Our Ref: M190009

**RESPONSE TO COUNCIL COMMENTS
NEPEAN BUSINESS PARK AMENDING DEVELOPMENT APPLICATION (DA25/5786)**

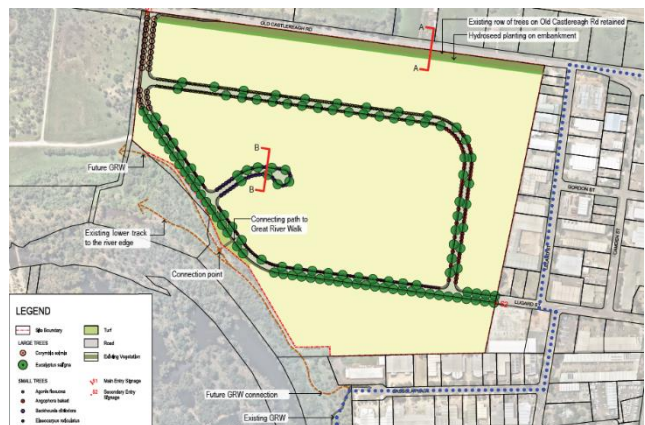
c) Concern is raised about the removal of connecting Road 02 within the subdivision to be replaced with a cul-de-sac. This has repercussions for access, travel paths, on street parking, street tree planting and lot widths.

DA25/5786 proposes Road 02 to include a cul-de-sac because there are fewer lots, less street frontage and fewer driveway crossing requirements that rely on Road 02 under the proposed Amending DA scheme. This is primarily due to proposed Lots 23, 83 and 37 which have absorbed 17 smaller lots from the layout approved with DA9876 (Mod 6). As a result, there is no need for Road 02 to provide a link to Road 01 in order to achieve vehicle access and egress.

Access to each of the proposed large lots is appropriate and the non-compliance with the minimum site width has been addressed in (d) below.

Provision for on-site parking will be determined with any future application for specific land uses within each lot. The subdivision itself does not generate demand for on-site and on-street parking.

The Landscape Plan indicates that street trees will be planted throughout the Road 02 cul-de-sac at the same rate per lineal metre of footpath reserve as the remainder of the subdivision and the Amending DA will not change street tree planting character and density in the footpath reserve in comparison to the approved DA9876(Mod 6).

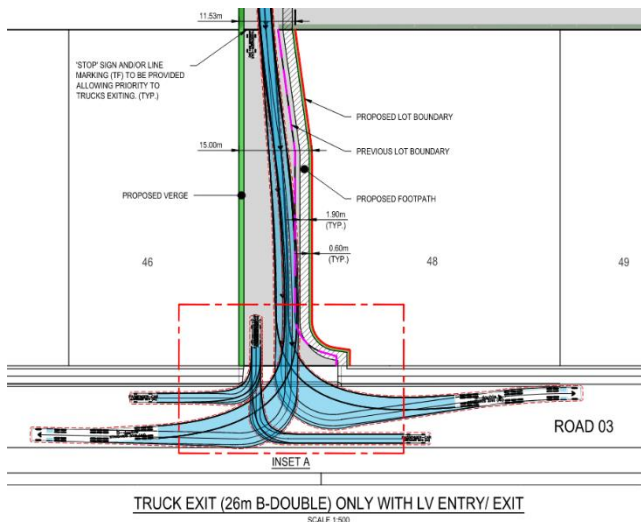
e) Question is raised about the reasons for the access handle to Road 03 from Lot 23. The reason for this seems unclear, noting particularly the irregular form of this connection. The provision of this access handle indicates that the lot may be designed for a pre-determined land use, the appropriateness of which has not been considered.

The access handle from Lot 23 was included to ensure flexible access options for the potential future subdivision. There is no pre-determined land use for this lot, and its final use will be subject to future development applications that will address use, layout, and compliance in detail.

The design of the access handle allows for the movement of passenger vehicles to enter from both directions and for B-double trucks to exit turning left and right. The design also allows for a footpath to the eastern edge of the accessway which will allow an efficient pathway between Lot 23 and the future 'hub' which will provide daily service needs for workers at the Nepean Business Park.

Additionally, Road 03 will be created in Stages 1 and 2 and the proposed access handle for Lot 23 facilitates installation of a point of access and services to Lot 23 at Stage 3 despite Lot 23 not being delivered until Stage 6B.
